SITE CONTEXT MAP
"FRANCIS PLAZA"/TACO BELL
1124 ARNOLD DRIVE

Re: Review of Parking Conditions and Vehicle Queuing for the Proposed Commercial Project on Arnold Drive in the City of Martinez

CITY OF MARTINEZ
DESIGN REVIEW COMMITTEE
COMMENT FORM

PROJECT: Francis Plaza DATE: 9/13/12

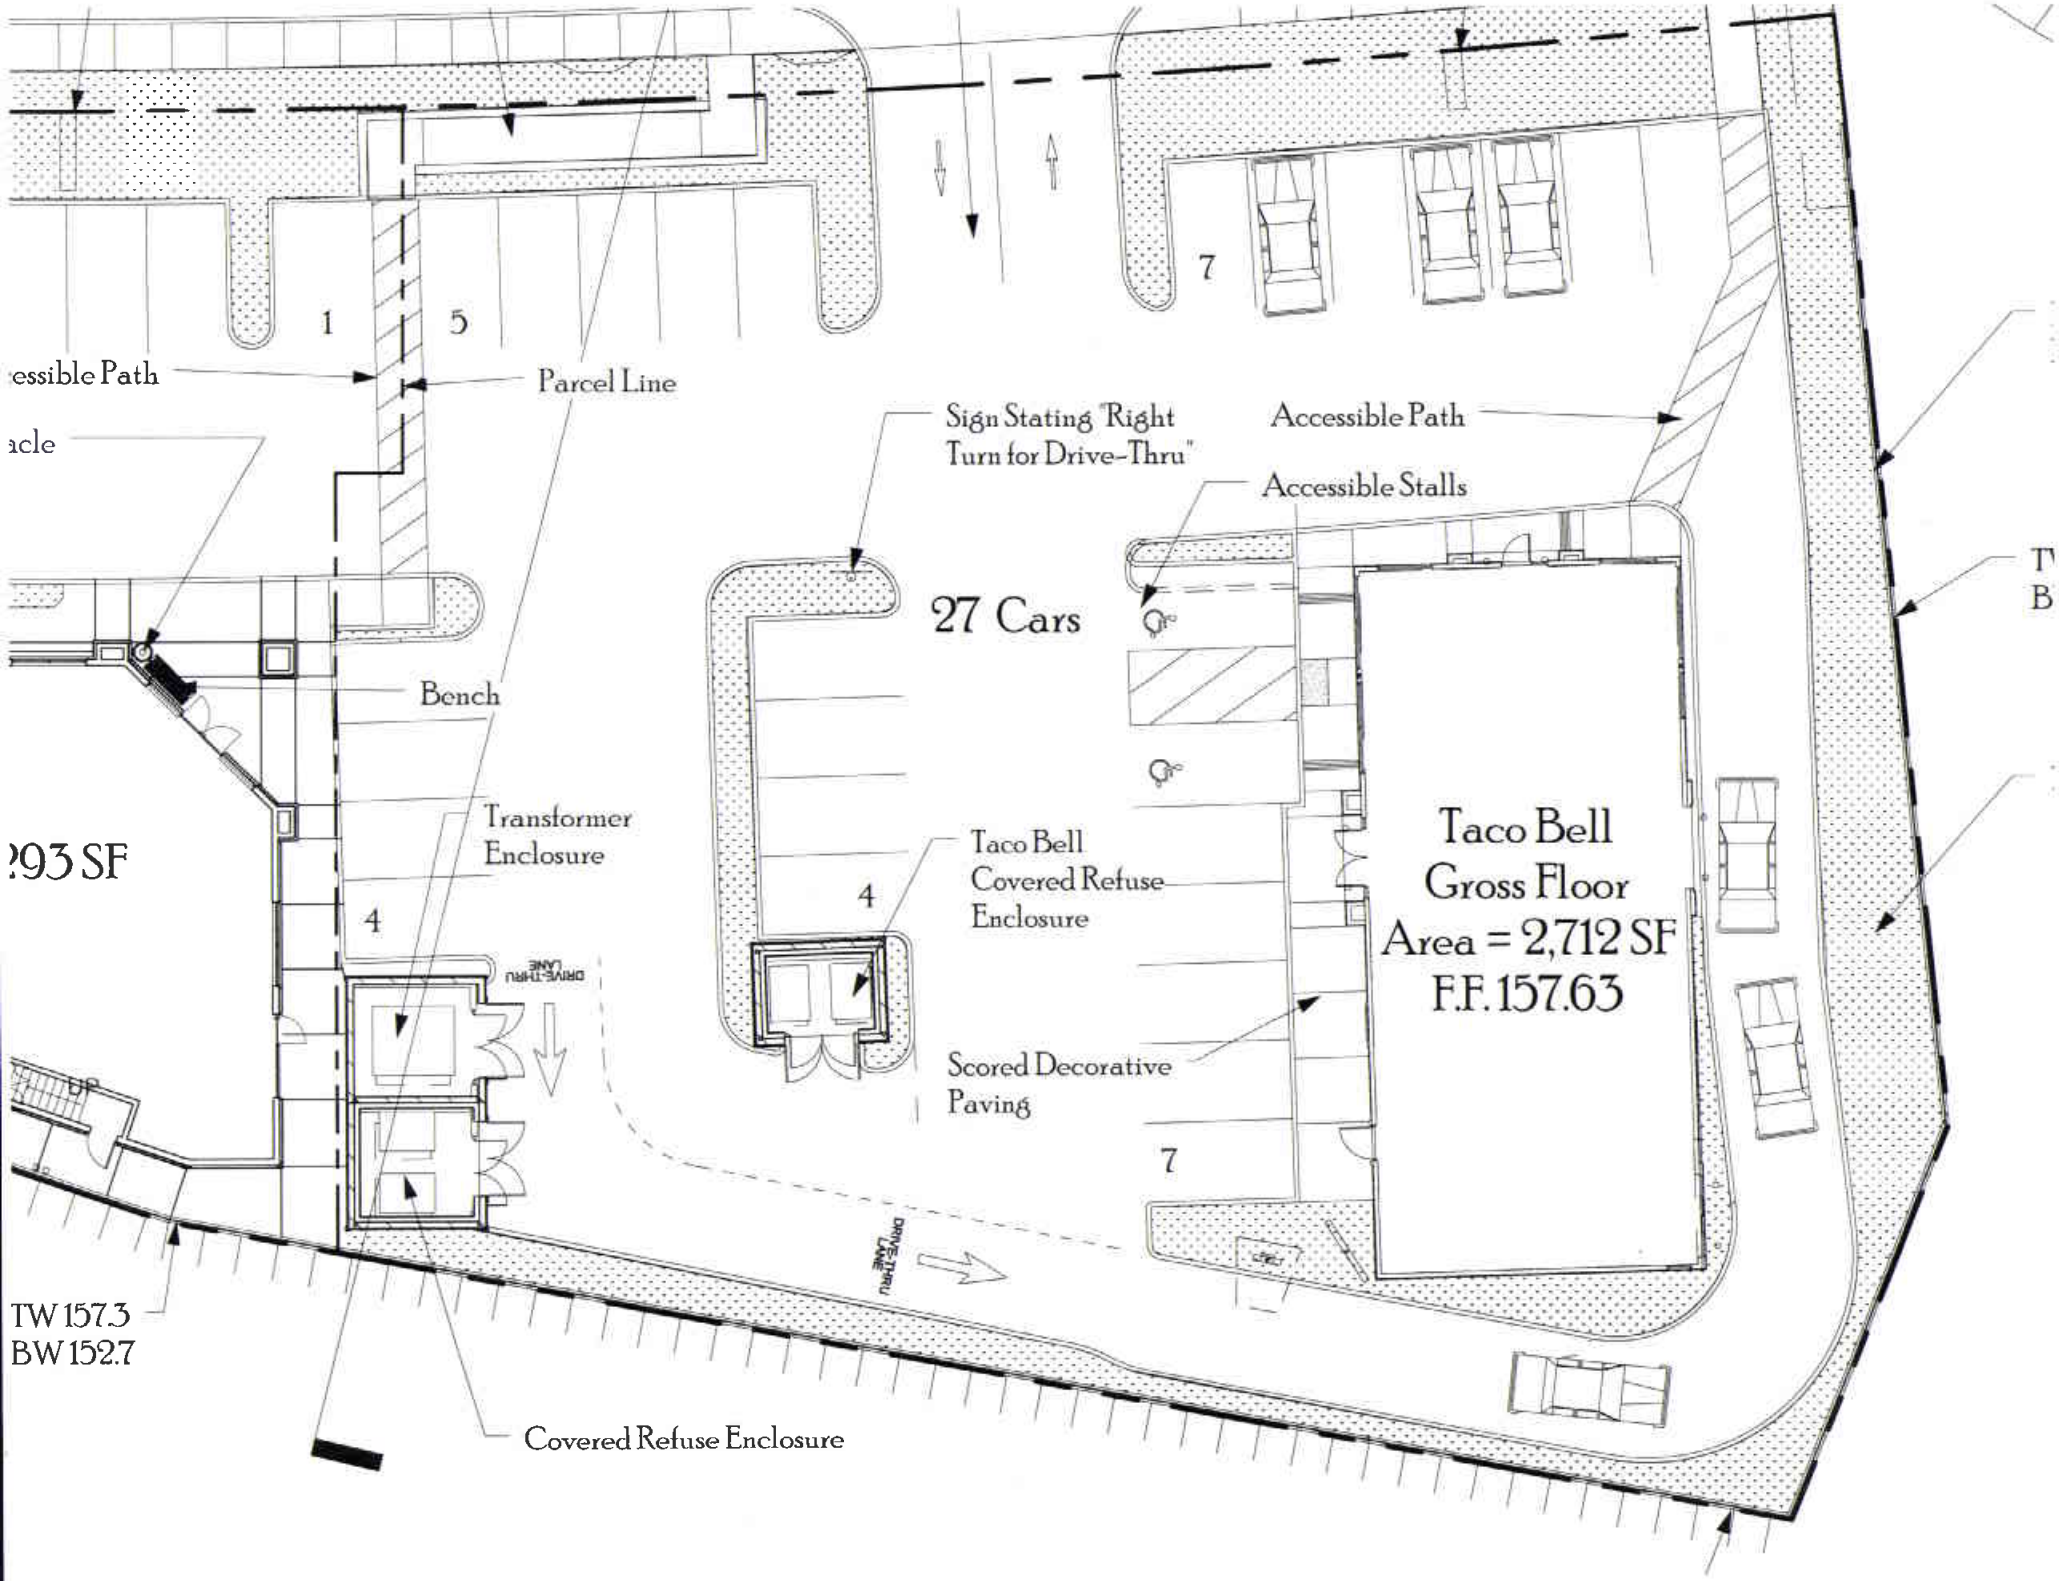
For vehicle queuing estimates it is common traffic engineering practice to estimate vehicle queuing as 20 feet per vehicle (please note the average vehicle is typically no more than about 18 feet long). Based on the maximum reported queue of 10 vehicles recorded at a Taco Bell approximately 200 feet of storage would be required to accommodate the maximum queue. Based on our preliminary calculations the site plan would allow for approximately 6 to 7 vehicles within the drive-through lane and room for about 3 to 4 additional vehicles without interfering with internal circulation or access to any of the parking spaces on the site.

It is important to note that even if we assume the maximum design queue of 12 cars that is recommended for fast food drive throughs in general (including all types of drive throughs) the additional queuing should not result in any problems for vehicle circulation on the site (i.e. blocking drive aisles). The only effect that would be expected if the queue were to exceed 12 vehicles is that it could make the four (4) spaces located on the east side of the office/retail building difficult to access during peak times. This should not be a significant problem and could be addressed by designating these spaces as employee spaces if that became necessary. In summary, the proposed site plan should have more than adequate space for queuing and there is no reason to believe queuing will cause internal circulation problems or traffic to back up out of the site on to Arnold Drive.
